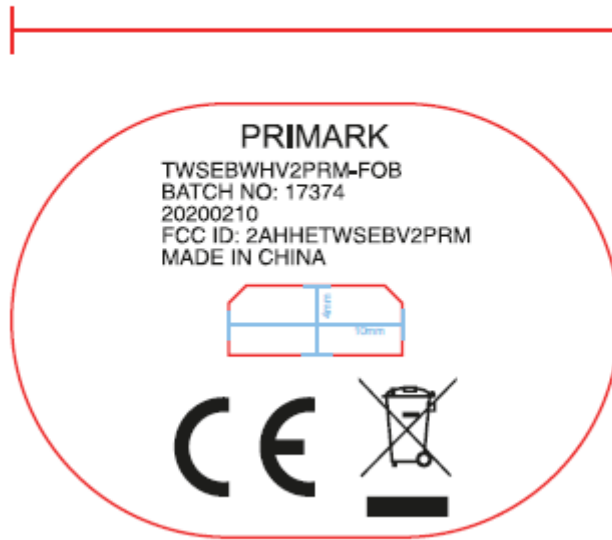
4pt font is not achievable on TWSEBBKV2PRM-FOB due to product dimensions. FCC ID is included in user guide.
